Number	Description
1	Revised Table of Contents; Revised NTB Nos. 458, & 459; Added NTB No. 460; Revised Bid Items; Revised or Added Plan Sheet Nos. 2,8-10,17,3001,3004,3006,3013-3017, & 3020; Amendment EBS Download Required.

MISSISSIPPI DEPARTMENT OF TRANSPORTATION
TABLE OF CONTENTS

PROJECT: HSIP-0003-01(192)/107127301 - Hancock

ADDENDUM

SHEET NUMBER 3013

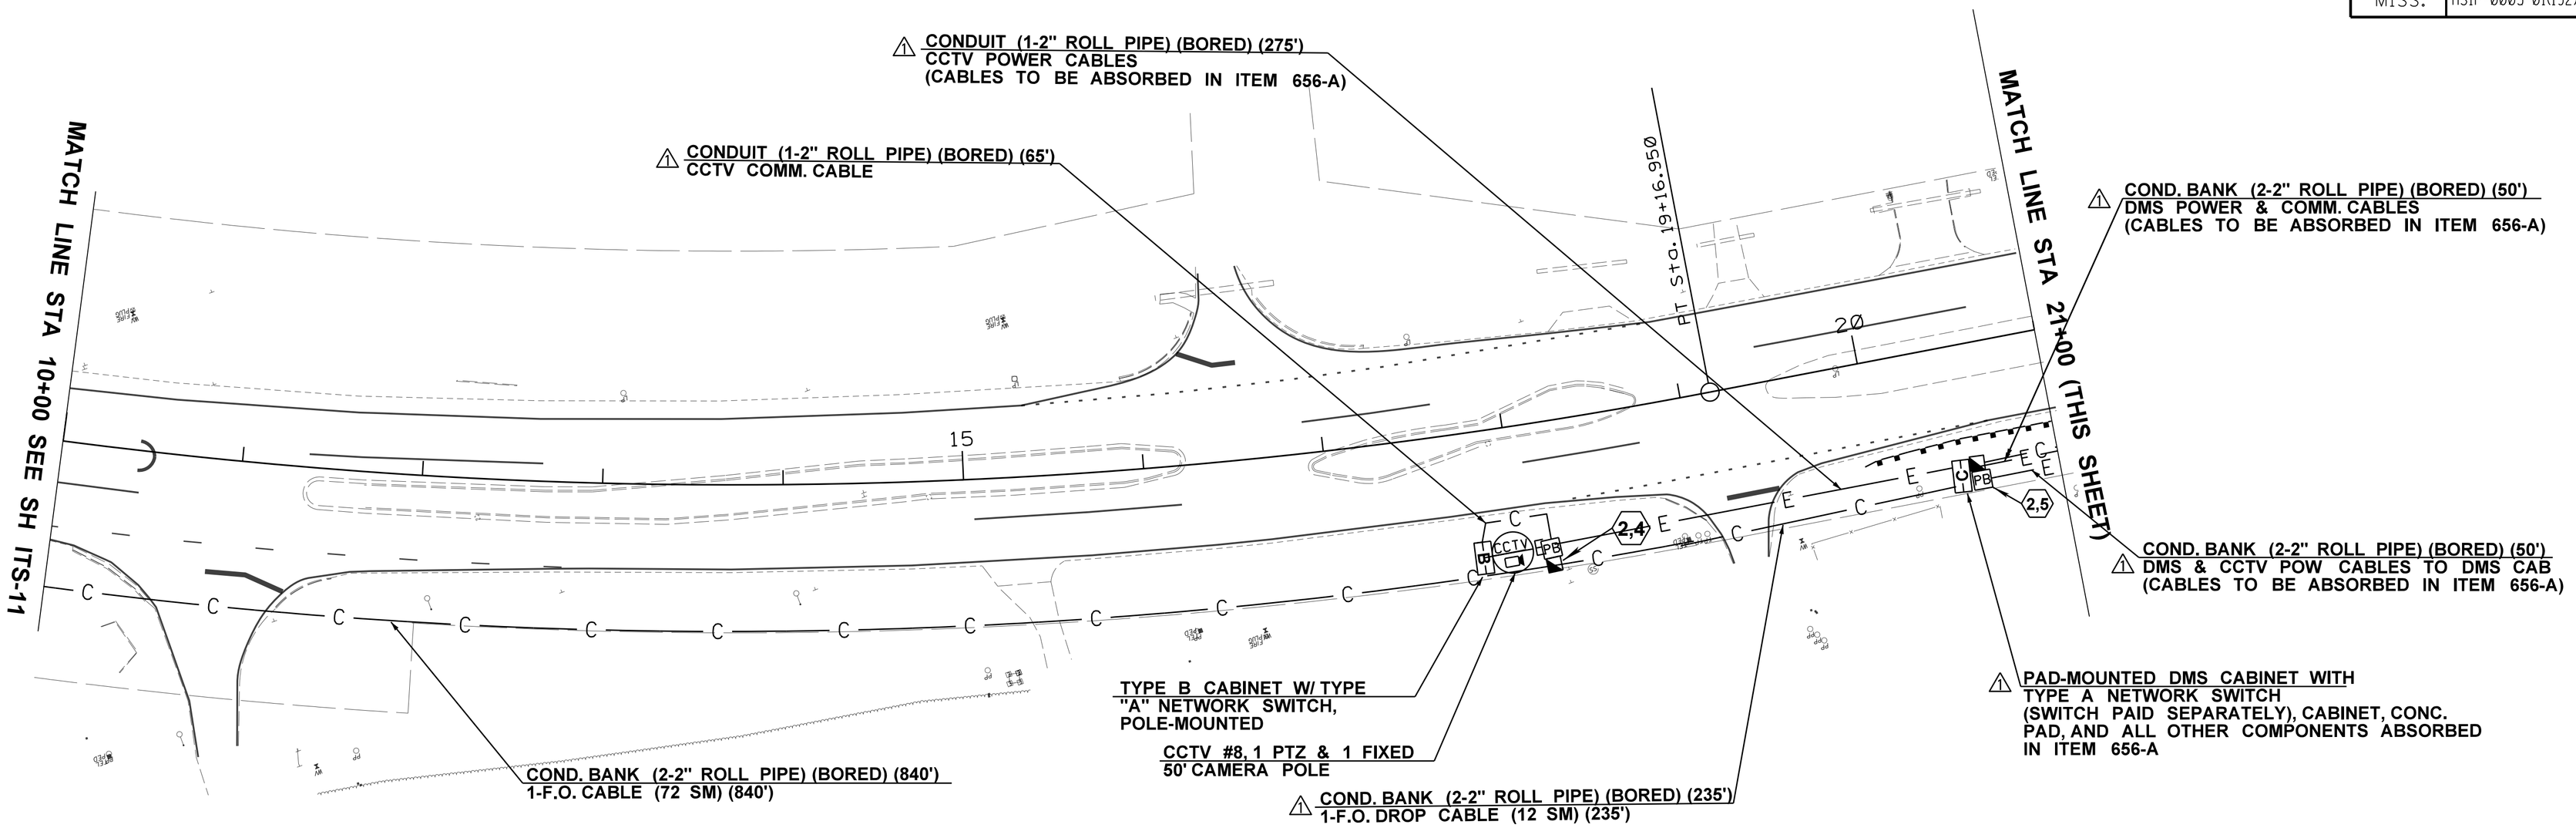
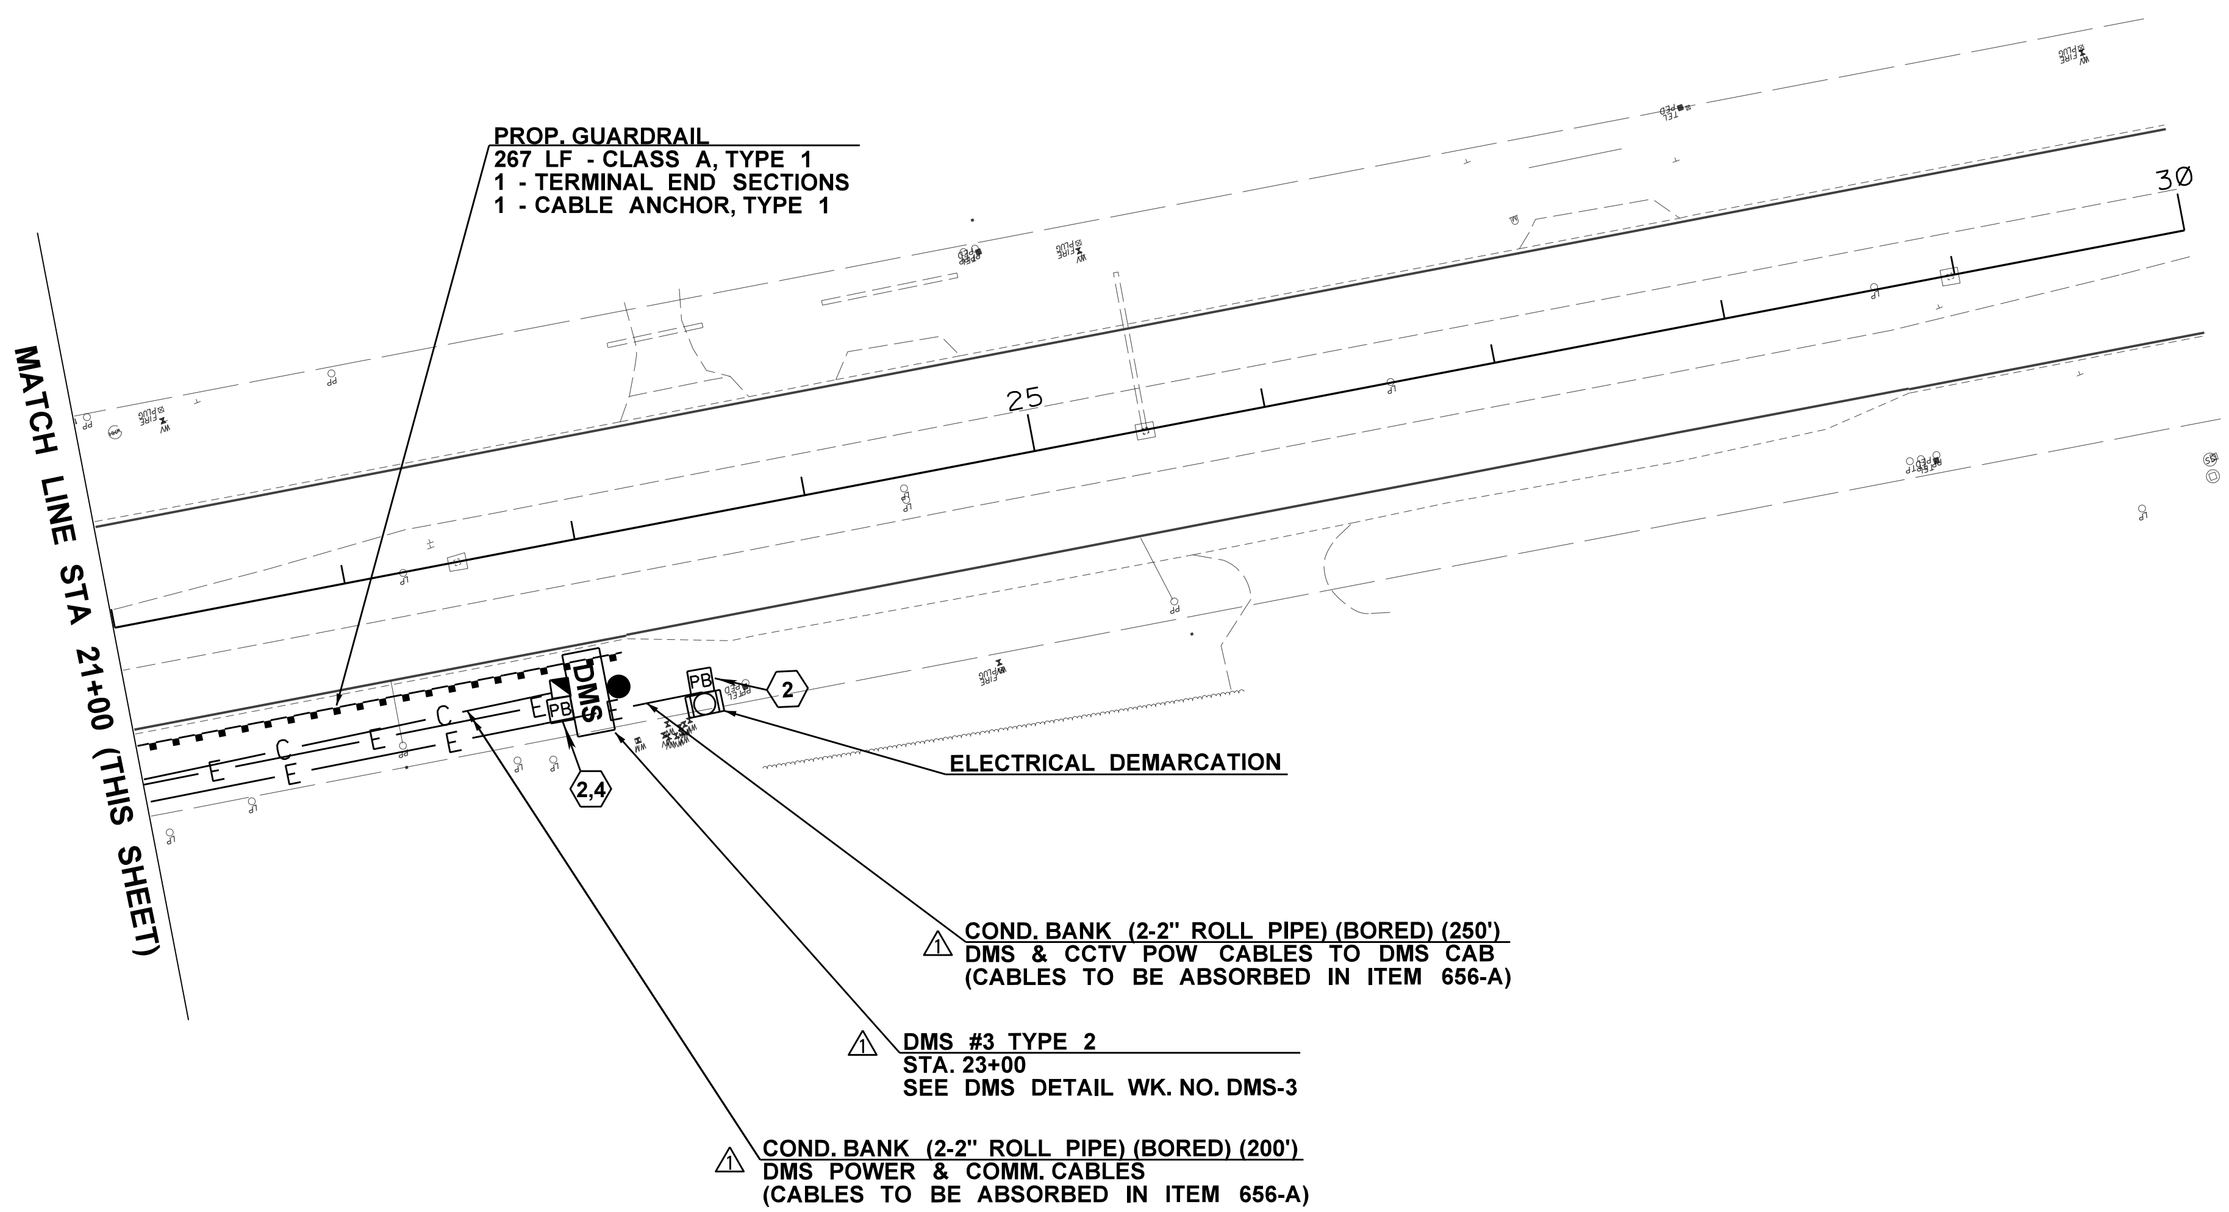
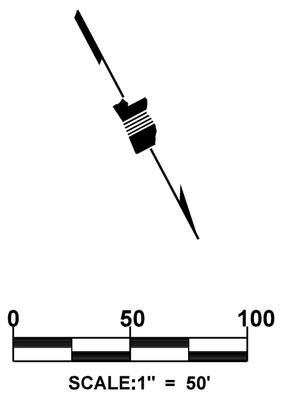
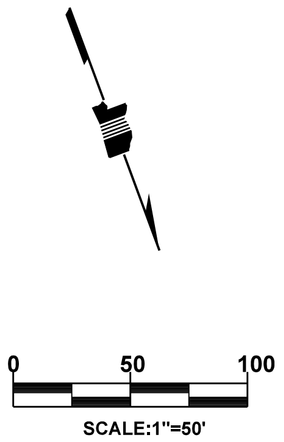
DATE	REVISION	BY	WRT
05-15-18	REVISED DMS NO., F.O. AND ELEC

SHEET NUMBER: 3014

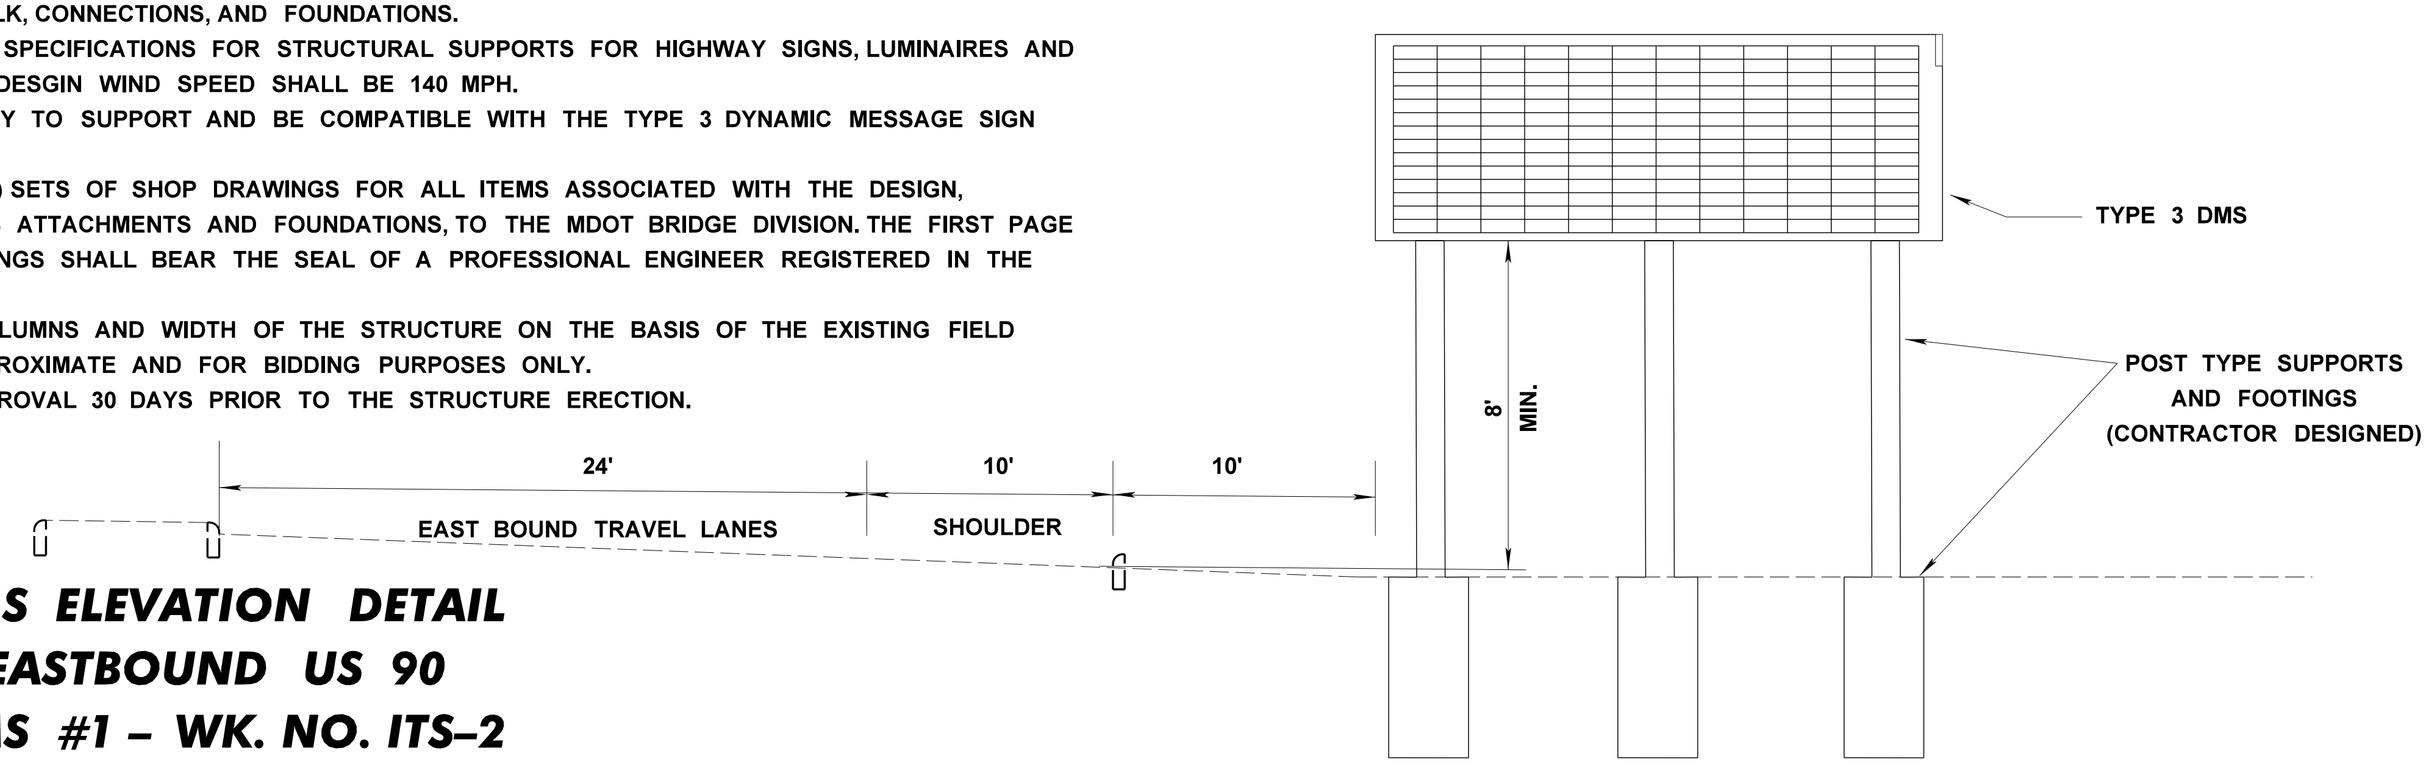
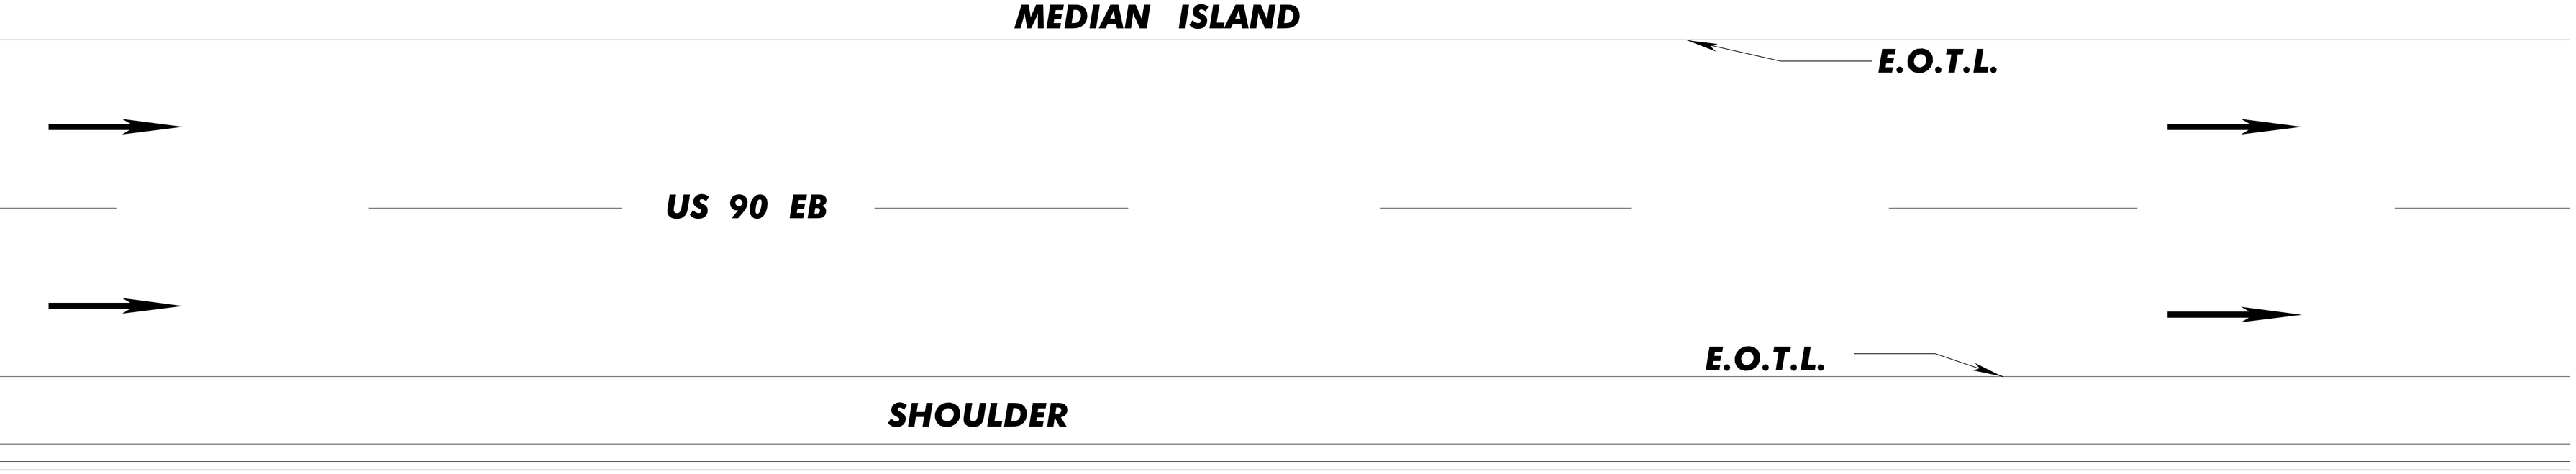
DATE	REVISION	BY	WRT
05-15-18	REVISED DMS NO., ELEC AND PAY ITEM

SHEET NUMBER: 3015

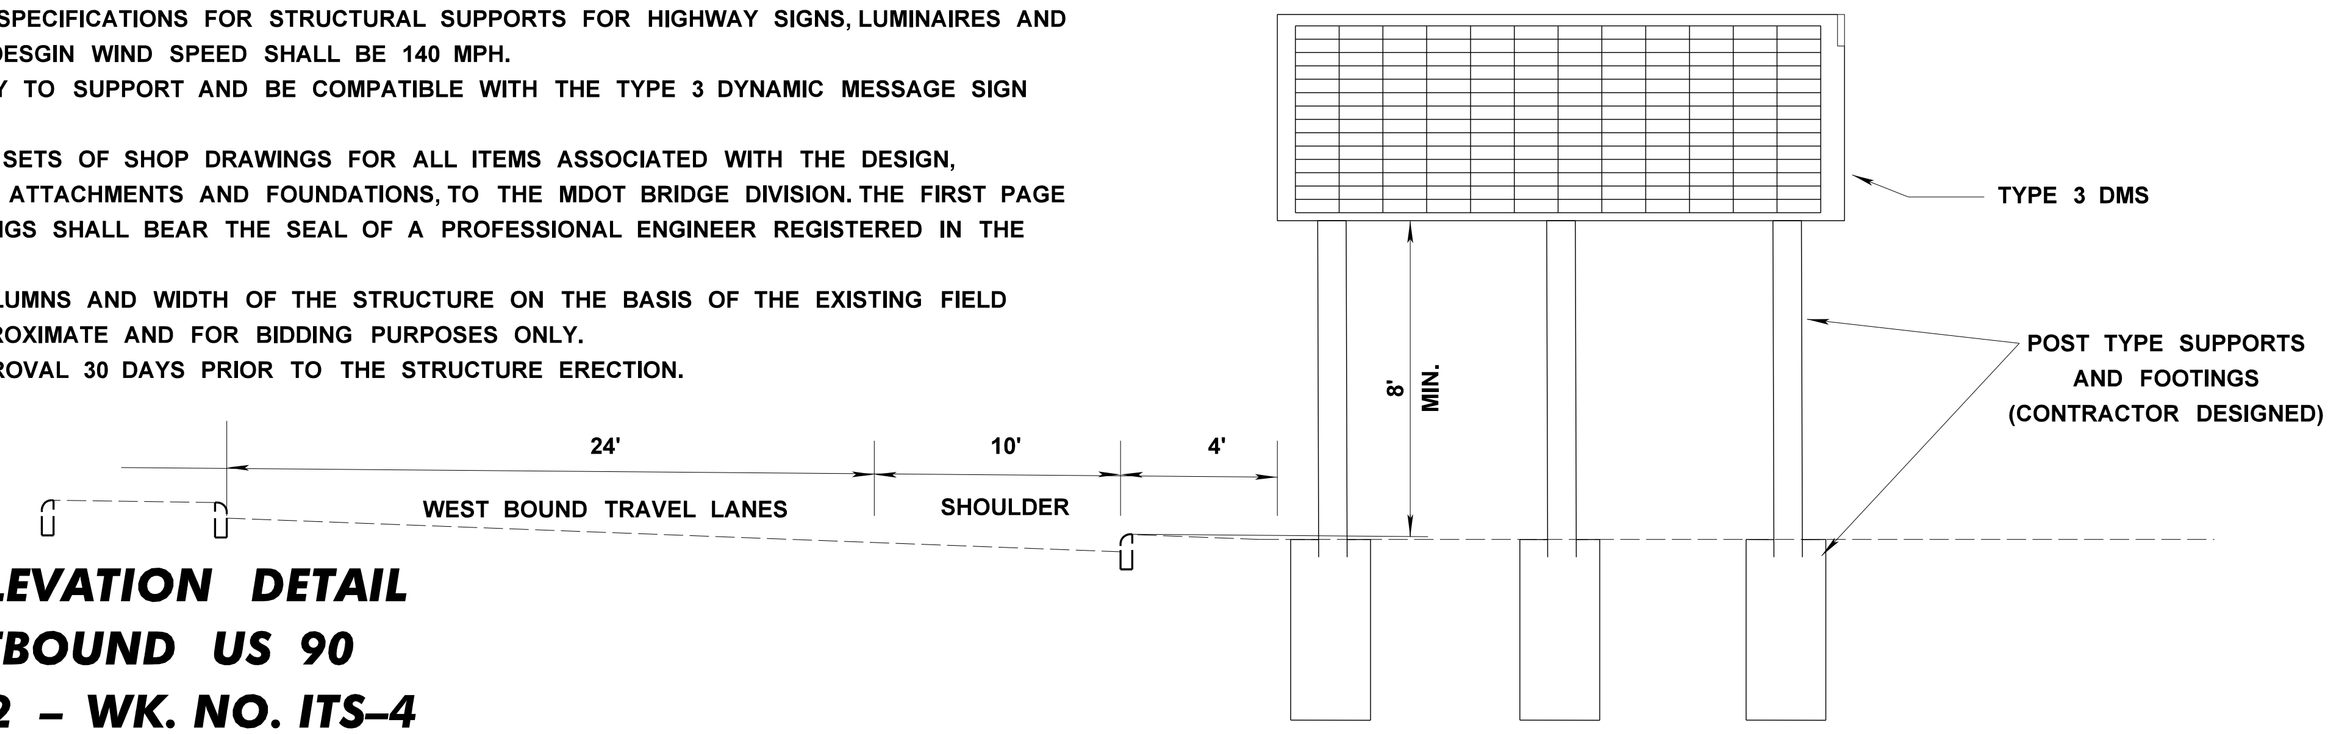
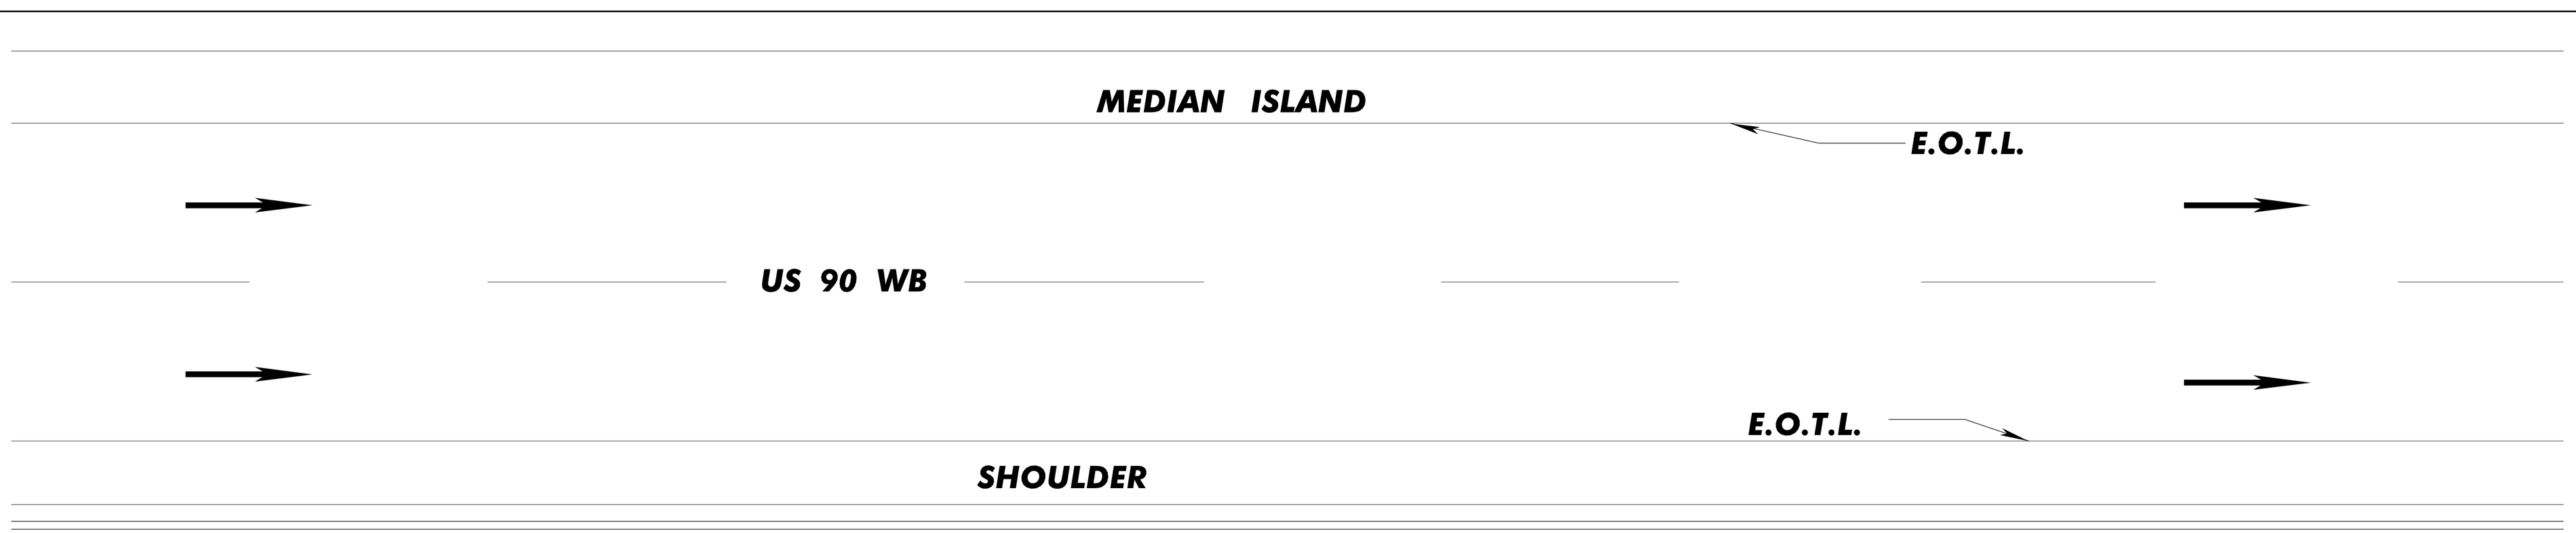
DATE	REVISION	BY	WRT
05-15-18	DMS NO. CHANGED
